Certificate of Appropriateness
1514 Rutledge St

October 5, 2020

Proposed Work

NEW FRONT PORCH 04.14.20 FOR LANDMARKS SUBMITTAL
1514 RUTLEDGE ST.
 MADISON, WI
2
 OF 4

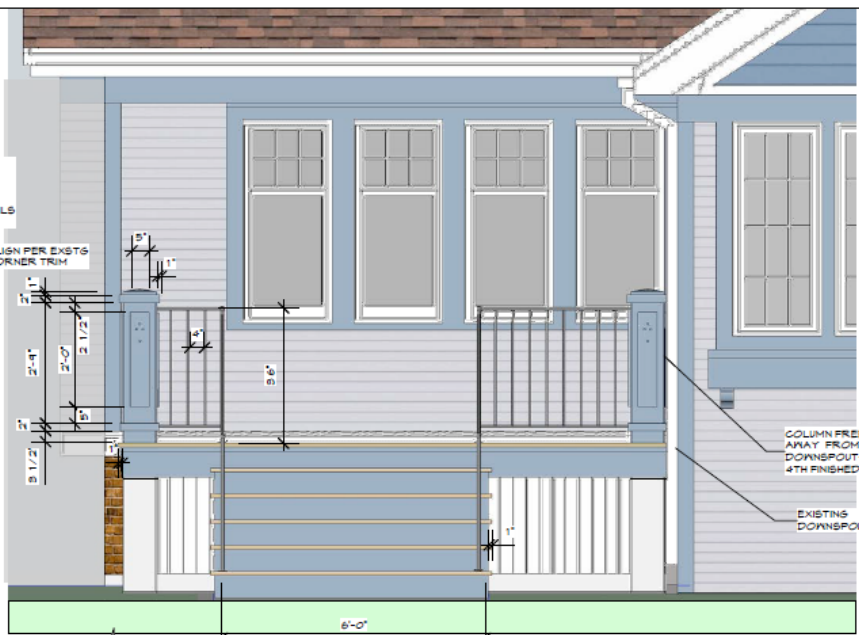
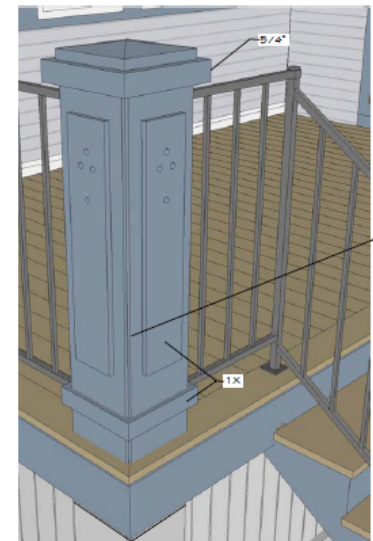
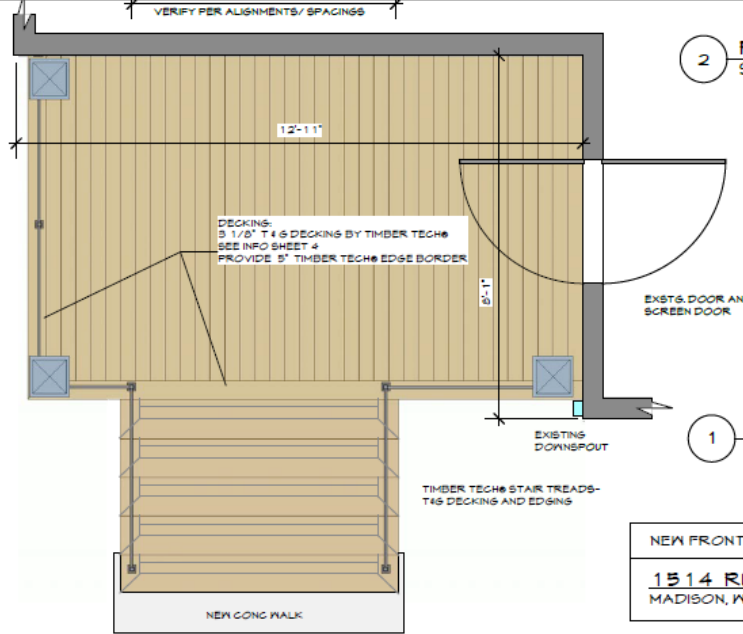
- Replace existing front stoop with a front porch in a form similar to others found on historic resources in the Marquette Bungalows Historic District

Staff believes that the standards for granting a Certificate of Appropriateness are met and recommends that the Landmarks Commission approve the project as proposed.
